## Chatham County Planning Board Agenda Notes

**Date: July 5, 2022**

**Agenda Item: VII-2**

<b>Subject:</b>	Request by Ben Mayo, P.E. of Withers Ravenel on behalf of Windjam Development (RBV 1525,LLC) for Subdivision First Plat review and approval of Flatiron Forest, consisting of 29 lots on 42.124 acres, located off Hamlets Chapel Rd (S.R. 1525), Parcel 2037.
<b>Action Requested:</b>	See Recommendation
<b>Attachments:</b>	<ol style="list-style-type: none"> <li>1. Major Subdivision Application and Checklist</li> <li>2. Vicinity Map</li> <li>3. School District Correspondence</li> <li>4. Letter from the NC Department of Natural and Cultural Resources, dated April 27, 2022</li> <li>5. Copy of Community Meeting Report Form dated May 10, 2022</li> <li>6. Copy of Soil Correspondence as well as Soil Scientist report and Soils Map</li> <li>7. Road Name Submittal Form</li> <li>8. Riparian Buffer Report, dated June 8<sup>th</sup> 2022</li> <li>9. USACE Notification of Jurisdictional Determination correspondence dated May 10<sup>th</sup> 2022</li> <li>10. TRC Comments, email correspondence from Chatham County Historical Association</li> <li>11. Topo Map</li> </ol>

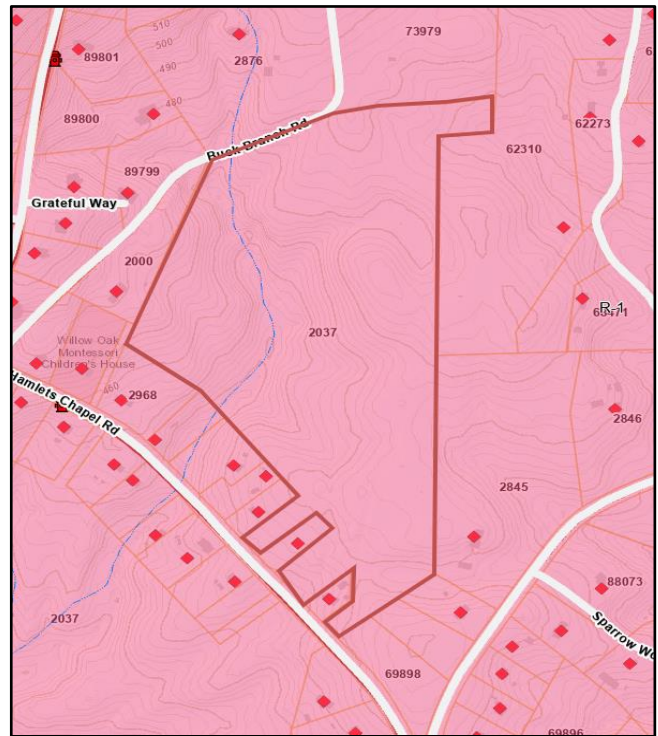
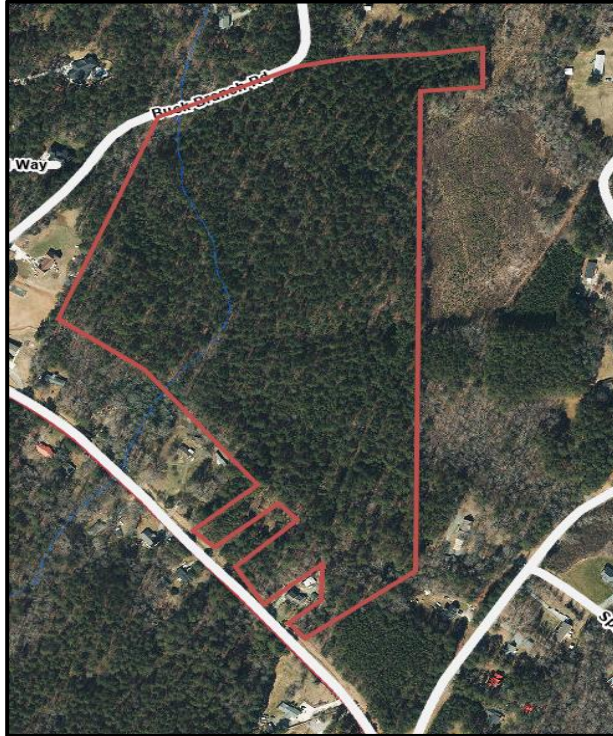
**Septic:** According to Environmental Health septic field layouts will be needed for 1,2,6,7,11,16,22,28, &29 depending on the amount of suitable soils that will be available

once the house sites are located. Central Carolina Soil Consulting, PLLC submitted a soil/site evaluation to the applicant on December 11<sup>th</sup>, 2021. The report is attachment 7.
